## MARTY FELDMAN CHEVROLET/KIA DEALERSHIP SP 10-31

### Planning Review of Preliminary Site Plan

### Engineering Review

**SUBJECT: Marty Feldman Kia & Chevrolet, Preliminary Site Plan,  
SP#10-31, Traffic Review**

Attachment

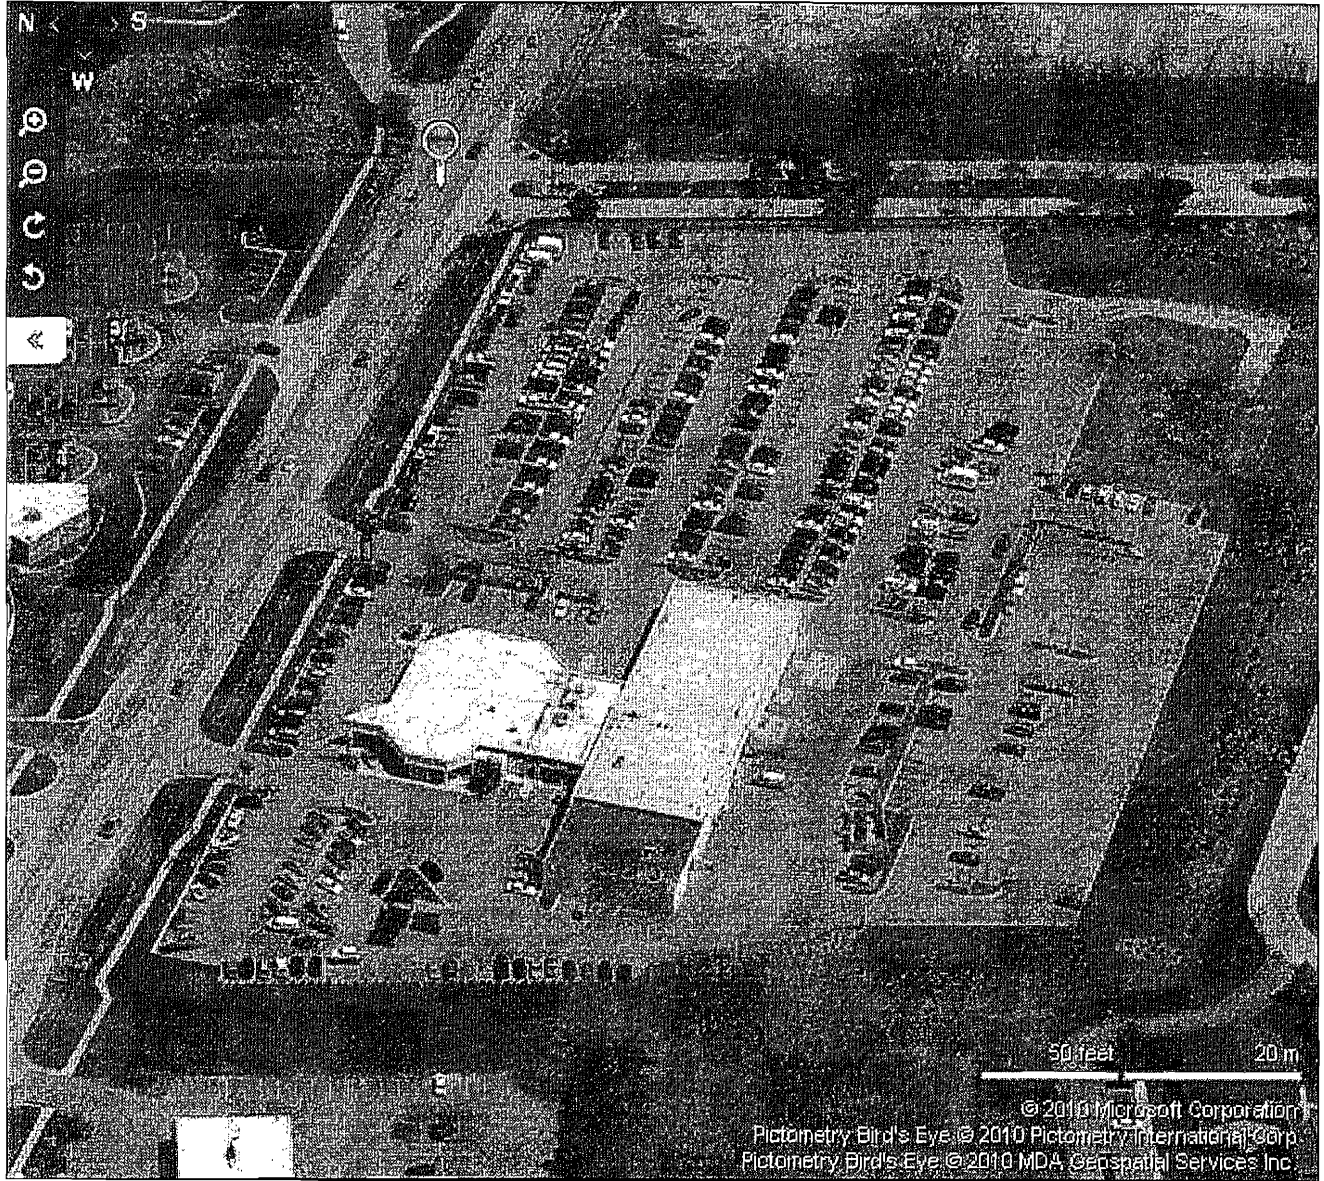
6. No driveway modifications have been proposed. However, **to improve circulation and meet current City standards, the curb radius on the interior east side of the east driveway should be increased to 15 ft.** This improvement will decrease the extent to which vehicles encroach on the wrong (left) side of the driveway and/or aisle as they exit the Kia portion of the site. Unlike the other three corresponding locations on the site, no sign relocation would be required for this island modification.

7. There are no paved connections to the Grand River sidewalk other than the driveways. **To provide a safe connection without having to relocate an existing light pole, the island for the proposed Kia sign should be shifted one parking space west, and a sidewalk stub to the parking aisle should be provided in the island adjacent to the sign.**

8. The turnaround "tail" for the dead-end parking lot adjacent to the proposed detention basin is too short (only 3 ft). **To lengthen this tail, the two attached parking modules east of the main north-south service drive should be shifted west by 3-6 ft (reducing the width of the end islands adjacent to that drive to 8-11 ft).**
9. **The radii on the southwest and southeast corners of the proposed new building pad should be dimensioned on the plan.** These radii are less than the City standard, but will be adequate for good circulation, given the over-width parking aisles east and west of the building.

- 1.-5. No comments.
6. The curb radius on the interior east side of the east driveway will be increased to 15 feet to improve circulation. This will be detailed on the final site plan.
7. A sidewalk stub and connection to the Grand River sidewalk will be provided in the island. This will be detailed on the final site plan.

8. The turn around tail for the dead end parking lot adjacent to the proposed detention basin will be extended by shifting the two parking modules to the west. This will be detailed on the final site plan.
9. The radii on the southwest and southeast corners of the proposed building pad will be dimensioned on the final site plan.
10. The typical length of a parking lot end island will be detailed on the final site plan and will illustrate the required 3-ft setback relative to the aisle.
11. The barrier free signs in front of the KIA building will be shifted south so they are located at the back of the walk. This will be provided on the final site plan.
12. The traffic signing table will be revised on the final site plan to remove the word "handicap" in the R7-8 description on the final site plan.

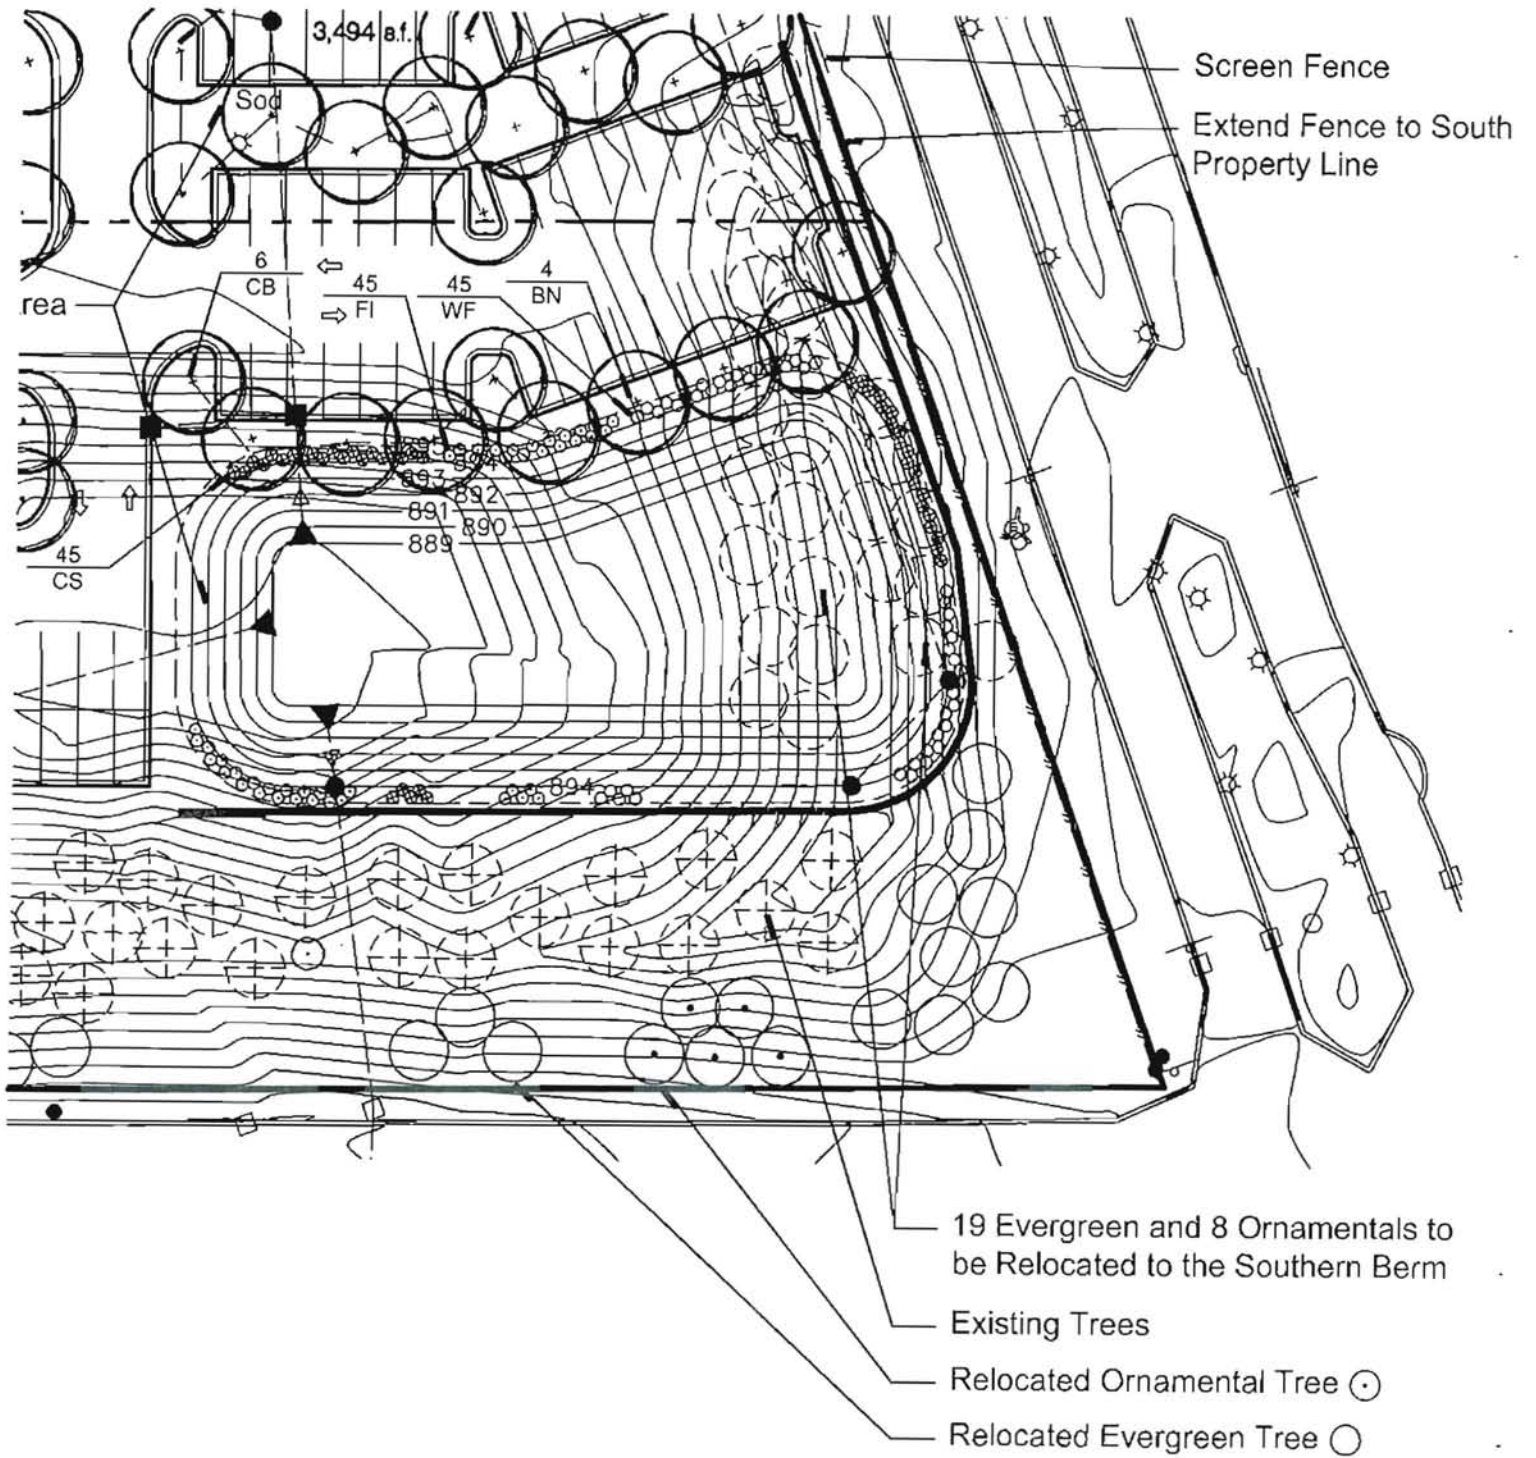
1. Mature vegetation located on the south berm currently buffers the site from adjacent residential property. This vegetation will be preserved. *The Applicant should show the existing vegetation in order to demonstrate that the existing vegetation forms and adequate buffer. In addition, the 19 evergreens and 8 ornamental trees to be relocated be shown in their approximate final locations on the plan.*

3. **A total of 70% to 75% of the storm basin rim area must be planted with native shrubs. The Applicant must provide these plantings. Final contour elevations should be shown on the plans to illustrate how the basin will blend with the existing grades.**

- Additional fencing is shown along the eastern property line. This fence will extend to the southeast property corner to better screen the proposed development.
- Shrubs have been added to the detention basin at the high water mark (894'). These plantings meet the 70%-75% coverage requirement.
- We have shown the proposed grading along the detention pond retaining wall. The top of wall meets existing grade in most instances.
- We have shown existing vegetation on the southern berm. We have also shown the locations for the relocated trees.
